NOTICE OF ERROR
REPLY

Water right number: 37-657B

Re: Notice of Error-Water Rights Valley Club Inc.
37-2623, 37-494, 37-657B, 37-495, 37-833K, 37- 0577BU, 37-057BV

VALLEY CLUB II
2006 Irrigation calculation
NAIP 2006 Aerial photo

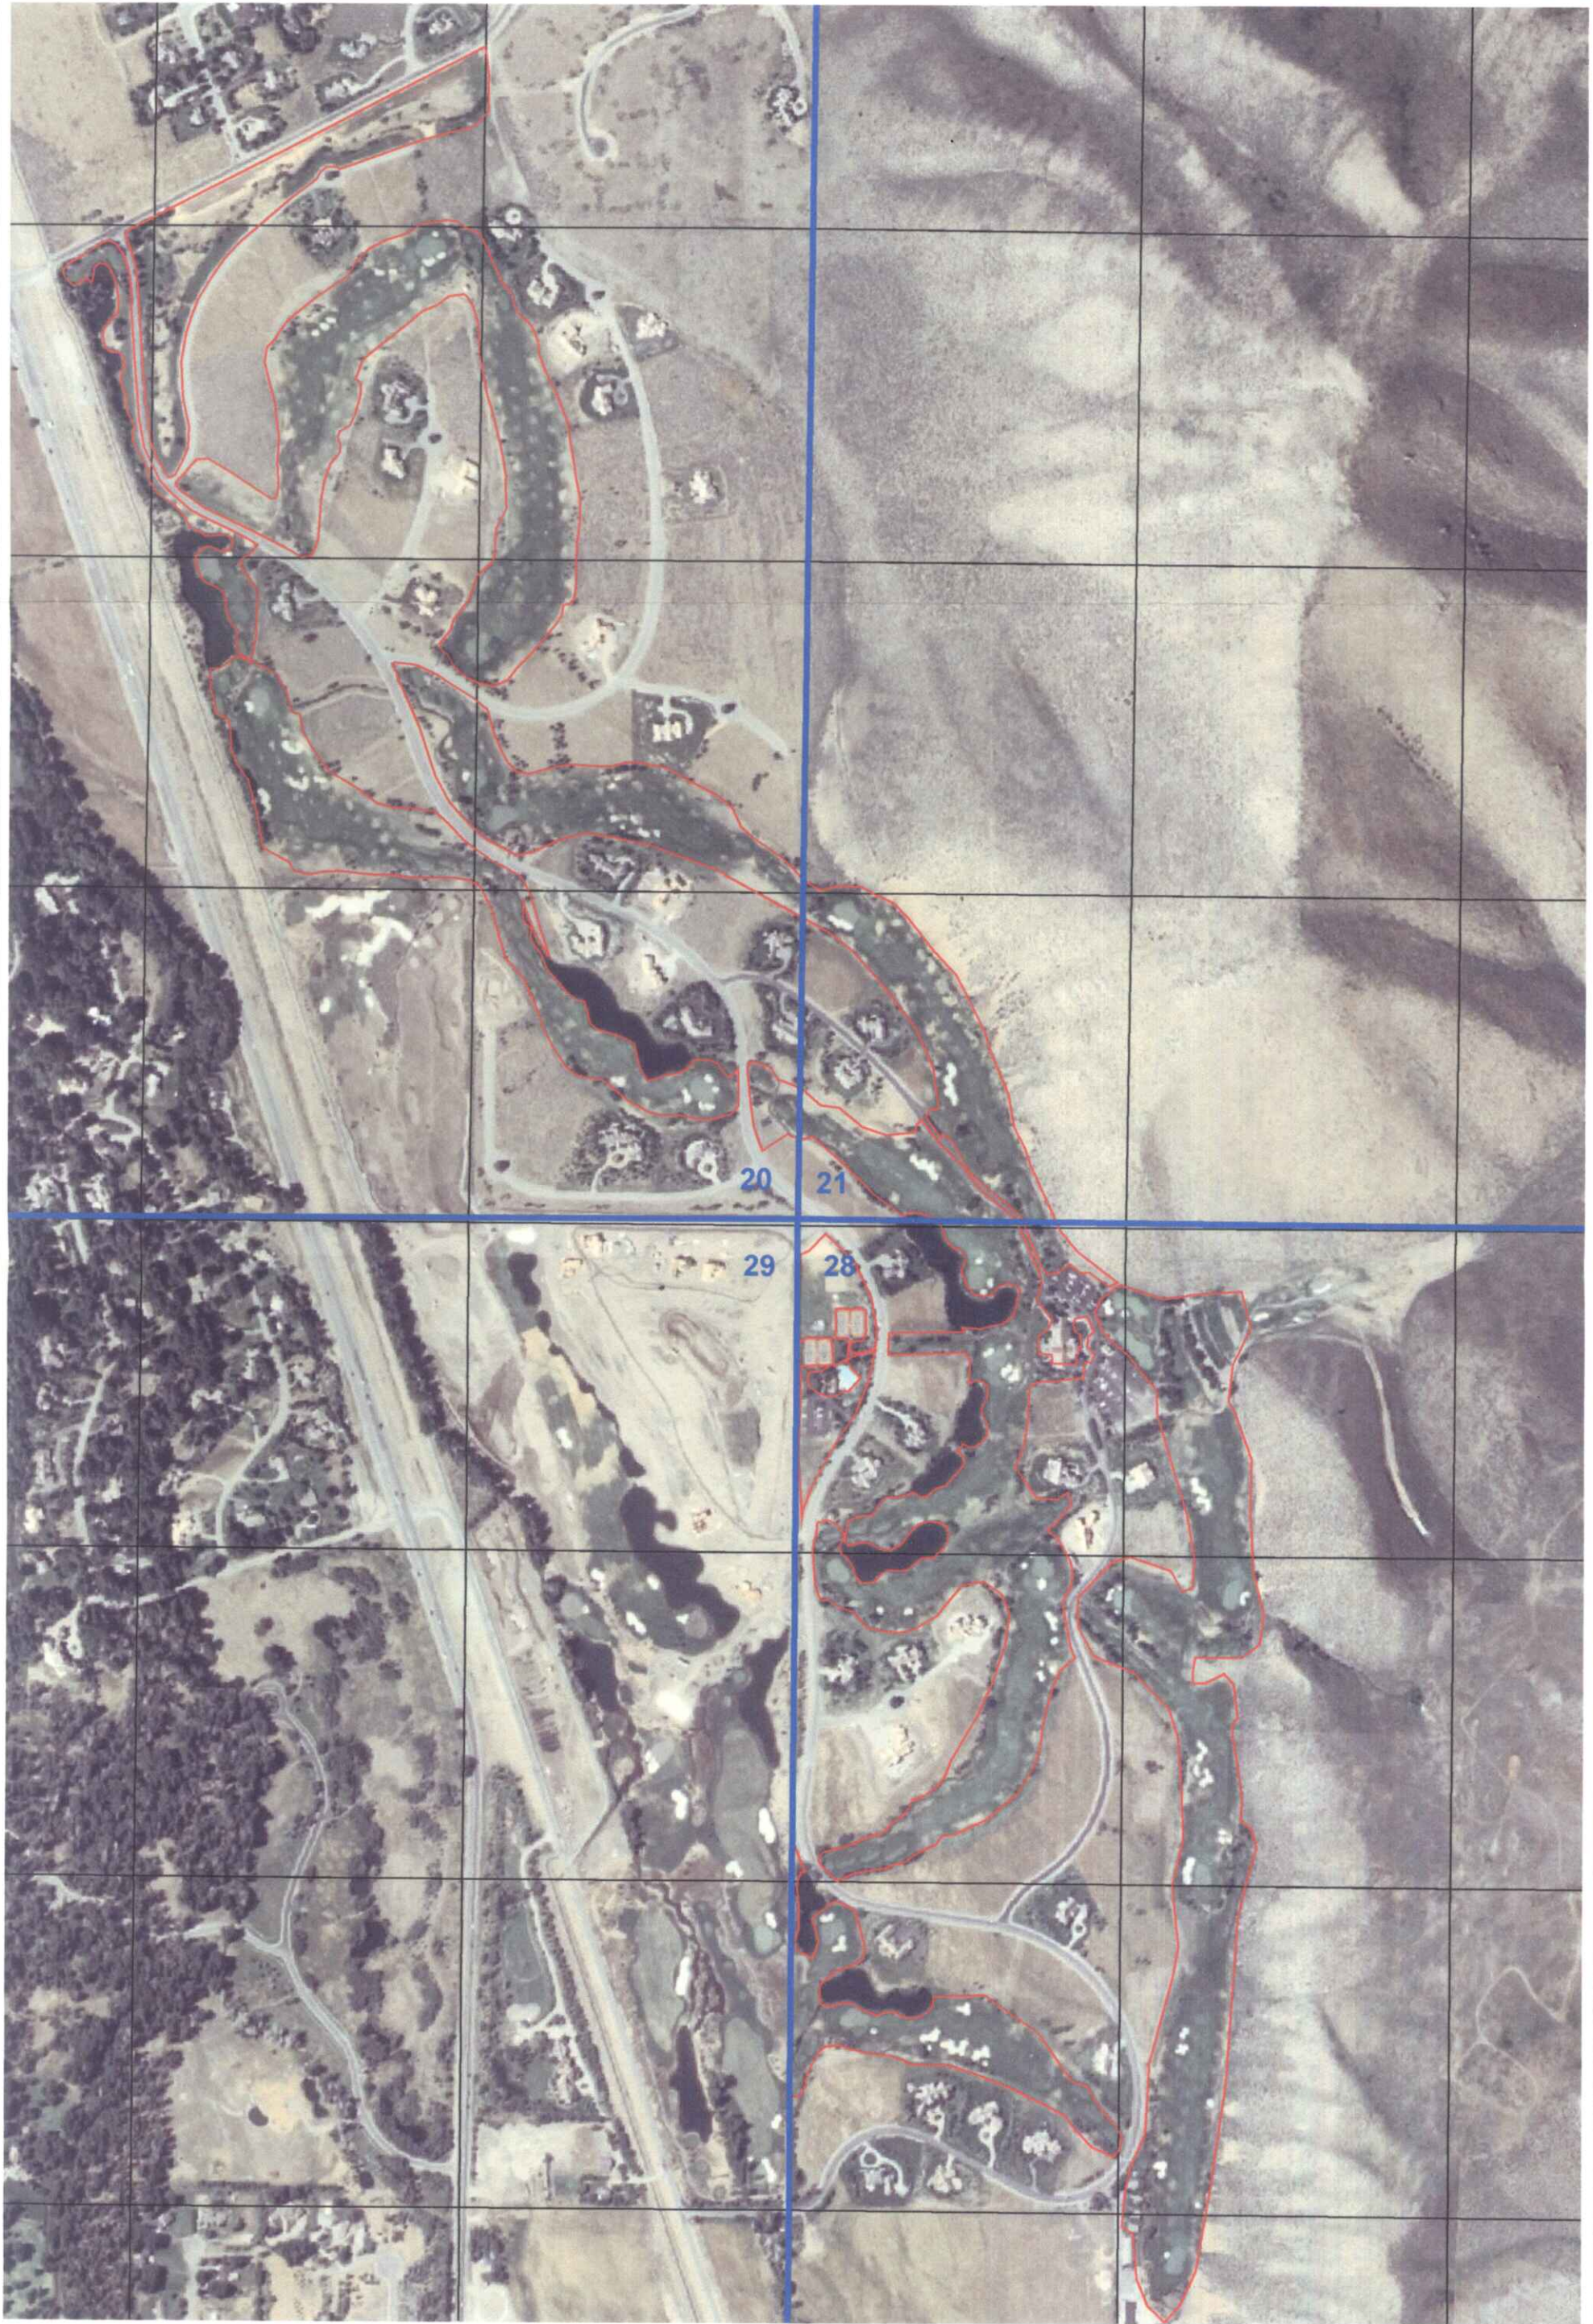
Water Right No.	Disagreement	Reason
37-2623	Recommended Acreage 120.7 ac. recommended, should be 143.8 ac.	IDWR .shp file is incorrect See attached table and Brockway Engr .shp file
	Limitation condition on rate of diversion and volume is incorrect	37-0577T and 37-0577V should be 37-0577BV and 37-0577BU
37-494	Recommended Acreage 120.7 ac. recommended, should be 143.8 ac.	IDWR .shp file is incorrect See attached table and Brockway Engr .shp file
	Recreation use should indicate that 0.15 cfs is for pond consumptive use	
37-495	Recommended Acreage 120.7 ac. recommended, should be 143.8 ac.	IDWR .shp file is incorrect See attached table and Brockway Engr .shp file
	Limitation condition on rate of diversion and volume is incorrect	37-0577T and 37-0577V should be 37-0577BV and 37-0577BU

Diversion location is incorrect Location of Hiawatha Diversion should be SESWNW Sec 20 T3N R18E	
37-833K	Recommended Acreage 120.7 ac. recommended, should be 143.8 ac.	IDWR .shp file is incorrect See attached table and Brockway Engr .shp file
	Limitation condition on rate of diversion and volume is incorrect	37-0577T and 37-0577V should be 37-0577BV and 37-0577BU
	Recommendation should state that water right is part of the "Rockwell Bypass Right" and is always in priority as long as the Rockwell Bypass is flowing 17.36 cfs.	
	Diversion location is incorrect Location of Hiawatha Diversion should be SESWNW Sec 20 T3N R18E	Hiawatha Canal diversion is in the SESWNW Sec 20 T3N R18E
37-0577BU	No recommendation as of 12/28/06	
37-0577BV	No recommendation as of 12/28/06	
37-657B	Check PLS description for Hiawatha Canal diversion	West 9 golf Trans #71721

Sum = 144.6 acres
Claim = 143.8 acres
Pre. Rec.= 120.7 acres
